USNRC APPLICATION
SUA-1341 License Amendment
Ludeman Project
Converse County, WY

June 2013

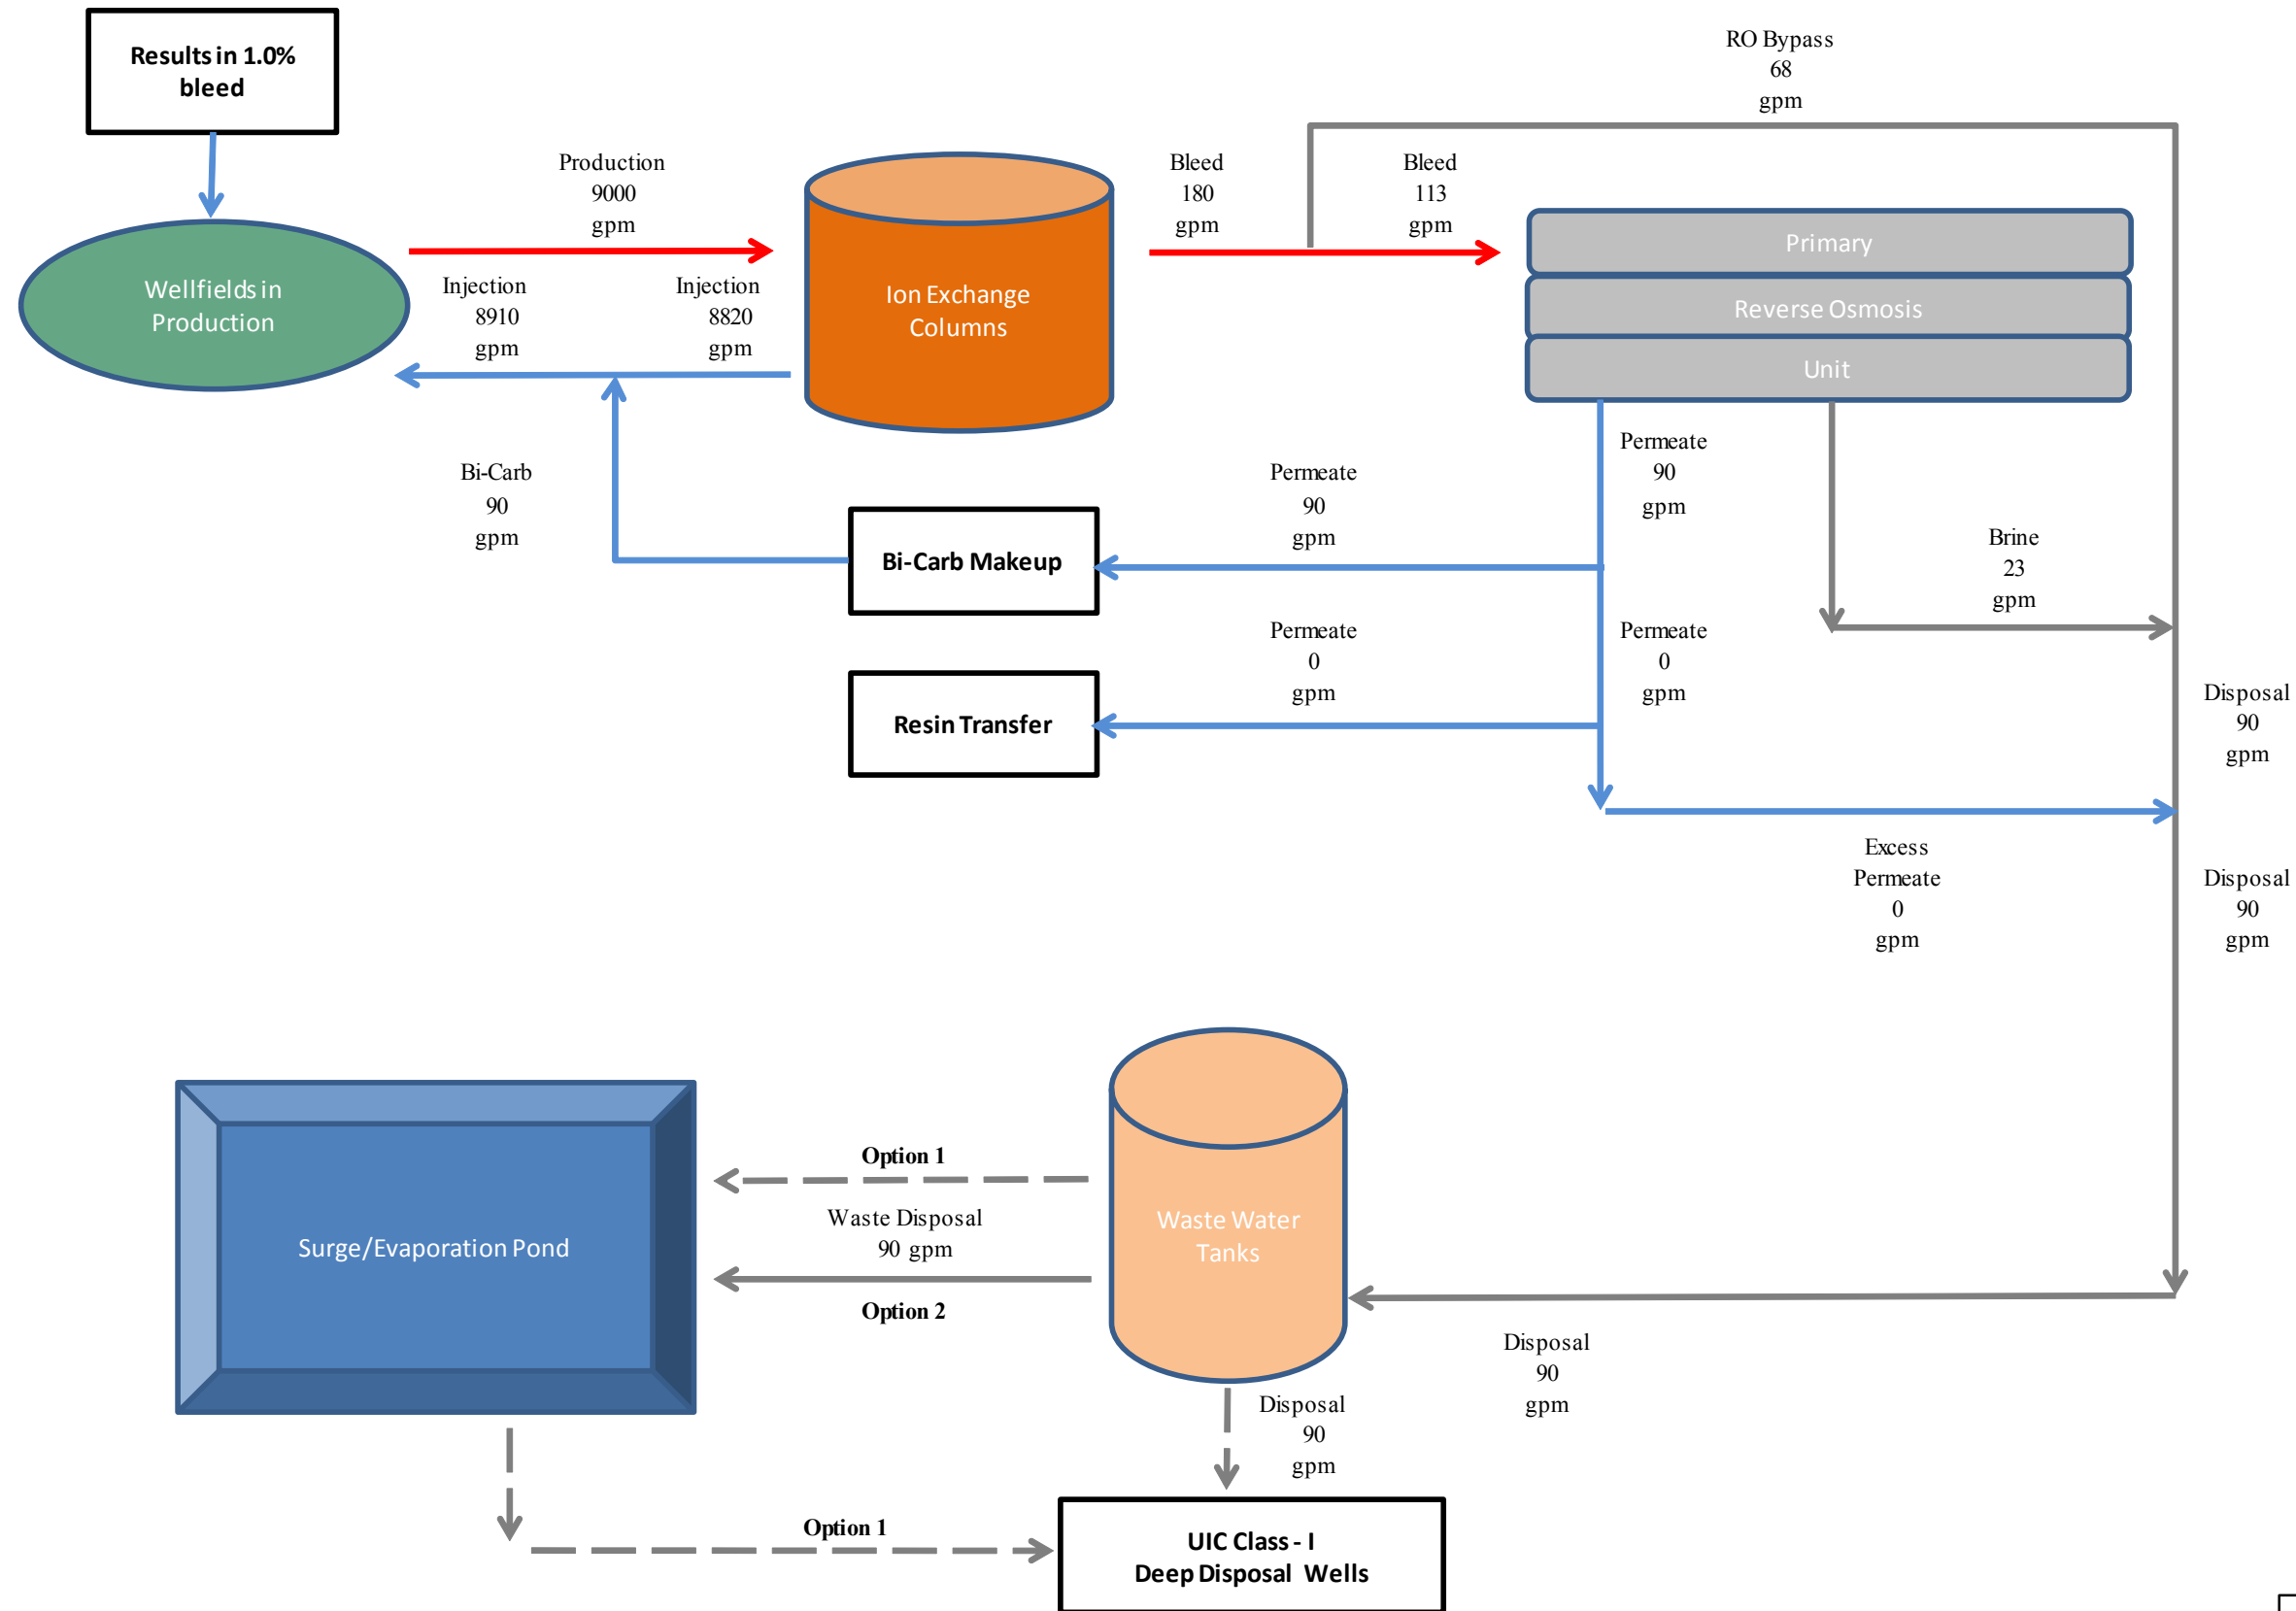
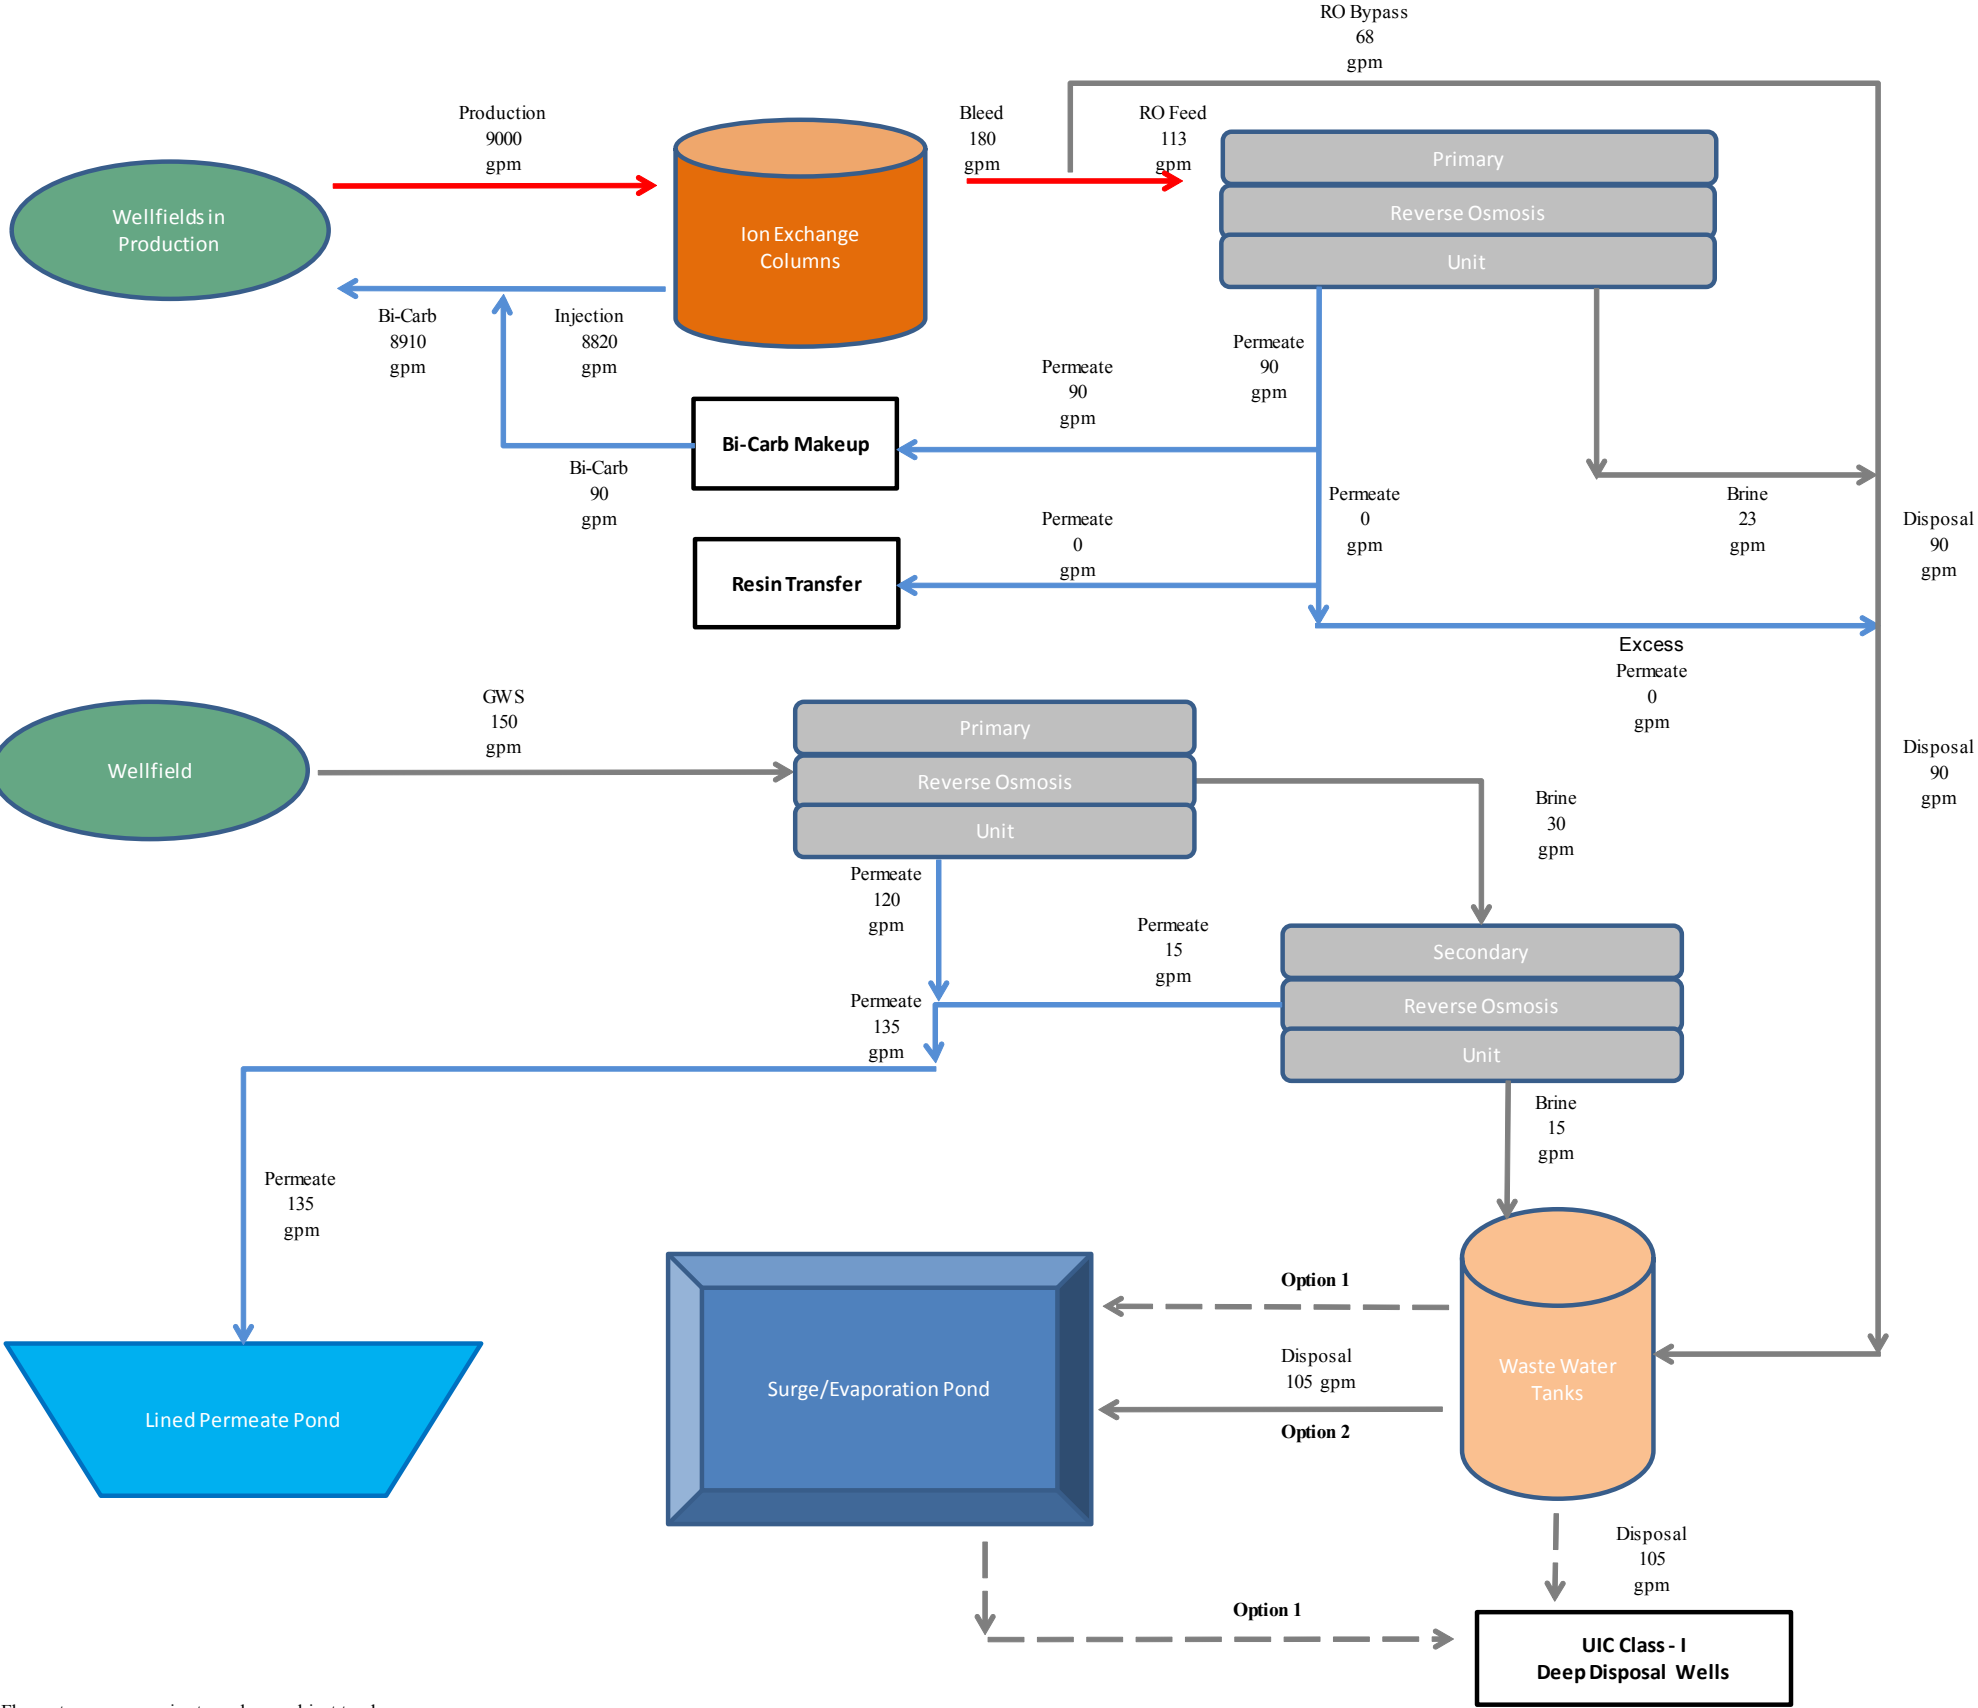
TR Section 3.1.6 presents a generic water balance for the production phase and restoration phase for all Ludeman satellites in Figures 3-6 and 3-7, respectively. The water balance was not specific to each satellite. The estimated waste disposal rate required at each satellite will be 60-160 gpm. The staff notes the field rates for existing DDWs in the Tecla Teapot Parkman formation (not projected permitted rates) at currently licensed ISR DDWs in the Powder River Basin are approximately 30 gpm on average. The TR indicates that only two DDWs will be installed for each satellite; therefore, each DDW would need to achieve rates of 30-80 gpm during operations. Staff cannot provide reasonable assurance that Uranium One has sufficient waste disposal capacity without a separate water balance at each proposed satellite for each phase of operation which includes realistic estimates of DDW rates based on field values from similarly situated DDW wells in the Powder River Basin.

Uranium One should: (a) provide a separate waste water balance specific to each proposed satellite and phase of operation including production, production/restoration restoration for each year of operation in table format; and (b) demonstrate that only two DDW will be sufficient to handle the expected waste disposal rates of 60-160 gpm at each satellite. If, Uranium One determines two DDWs will not be sufficient, address how sufficient disposal capacity will be achieved.
